Access Compliance Report Public Rights-of-Way (Curb Ramps)

Intersection ID: 23533	Main Street: QUAIL_FOREST_DR	Cross Street: QUAIL_HOLLOW_RD	Location: NW
ADA ID: AF2F78A06520	Ramp Type: PerpDiag	Initial Pass/Fail: Fail	Overall Compliance: No Severity Score: 22.5

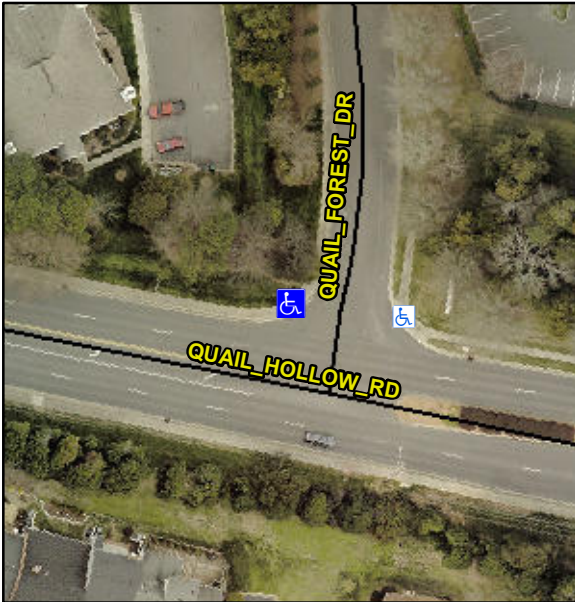
R304.5.1, R304.2.2, R304.5.3

Compliance	Description	Data	Compliance	Description	Data
N/A	Ramp Length (in)	59.0	No	Ramp Slope (%)	11.7
No	Ramp Width (in)	36.0	No	Ramp XSlope (%)	2.5
N/A	Flare Type LT	N/A	N/A	Flare Type RT	N/A
N/A	Flare Slope LT (%)	N/A	N/A	Flare Slope RT (%)	N/A
N/A	Flare Traversable LT?	N/A	N/A	Flare Traversable RT?	N/A
N/A	Landing Length (in)	N/A	N/A	DWS Provided?	N/A
N/A	Landing Width (in)	N/A	N/A	DWS Contrast?	N/A
N/A	Landing Slope (%)	N/A	N/A	DWS Length (in)	N/A
N/A	Landing X Slope (%)	N/A	N/A	DWS Full Width?	N/A
N/A	Landing Curb? (Y/N)	N/A	N/A	DWS Offset (in)	N/A
N/A	Shared Landing?	N/A			
N/A	Gutter Ponding?	N/A	N/A	Gutter Slope (%)	N/A
N/A	Gutter Lip Ht (in)	N/A	N/A	Gutter X Slope (%)	N/A
N/A	Painted X Walk1?	No	N/A	Painted X Walk2?	No
	X Walk 1 Direction	To S		X Walk 2 Direction	To SE
N/A	X Walk 1 Width (in)	N/A	N/A	X Walk 2 Width (in)	N/A
	X Walk 1 Slope (%)	3.2		X Walk 2 Slope (%)	4.3
	X Walk 1 X Slope (%)	2.5		X Walk 2 X Slope (%)	1.7

Possible Solutions:
Remove & Replace Curb Ramp With Two New Directional Ramps or Equivalent.
